**Group of Experts for the revision of the IMO/ILO/UNECE  
Guidelines for Packing of Cargo Transport Units**

**Updates on the second draft of the Code of Practice for Packing of Cargo Transport Units**

**Comments on the second draft of the CTU Code**

**Transmitted by the expert of Germany**

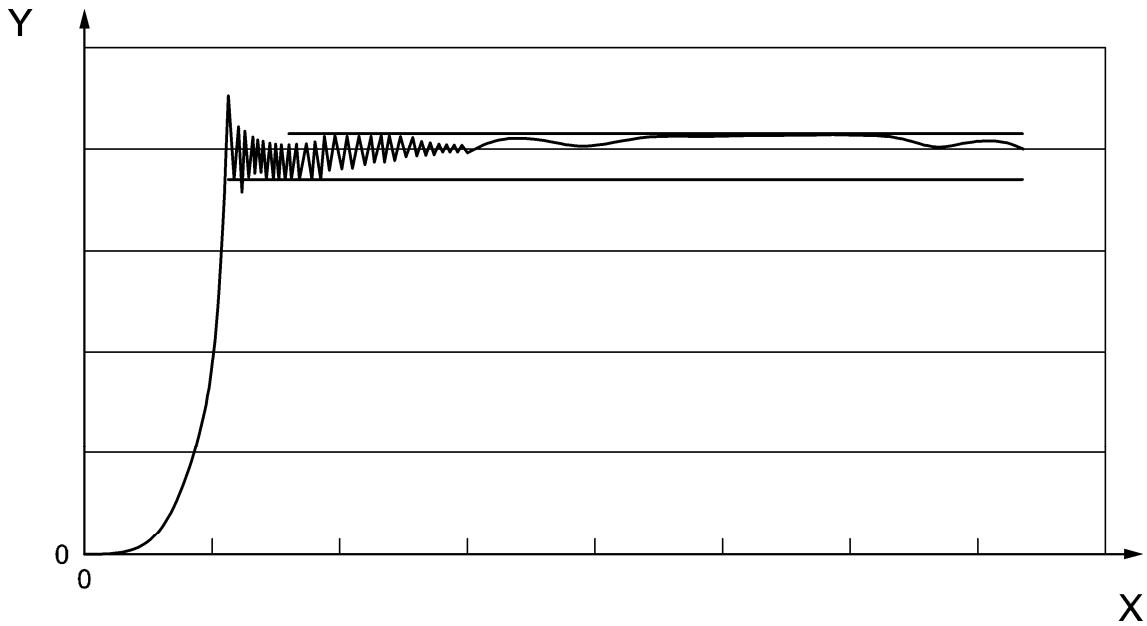
This annex should have the following wording:

*Justification: Annex 6 as proposed introduces the inclination test only, does not mention the pulling test and is not consistent with standard EN 12195-1:2010. It is proposed to describe the pulling test as well and to describe all test conditions as outlined in the agreed standard.*

#### 2 Pulling test

The test rig consists of the following components:

- horizontal floor with a surface representing the cargo platform
- test device for tensile tests
- connecting device between the test equipment and the bottom of the cargo unit
- PC based evaluation system.

The tensile device shall meet ISO 7500-1.

The test conditions have to correspond with real ones; the contact surfaces have to be “swept clean” and free from impurities. Tests should be executed in an atmospheric condition 5 in accordance with ISO 2233:2001 at a temperature of + 20°C and 65% relative humidity.

The pulling speed should be 100mm/min, the sampling rate shall be at least 50 Hz.

A measurement of pulling force and way of displacement is made with the same test object in one arrangement with a respective glide path of 50 mm to 85 mm for each stroke. At least three individual strokes have to be carried out with an intermediate unloading of at least 30% of the pulling force per measurement.

A measurement series consists of three measurements for each of three strokes. The test piece and/or anti slip material has to be replaced for each measurement, so that any influence of material wear on the result of the measurement can be excluded.

Key:

X way of displacement  
Y pulling force

The friction factor  $\mu$  has to be determined according to the equation mentioned below, taking into account the three medium values of each of the three measurements:

$$\mu = (\text{pulling force} \cdot 0.95) / (\text{weight} \cdot 0.925)$$
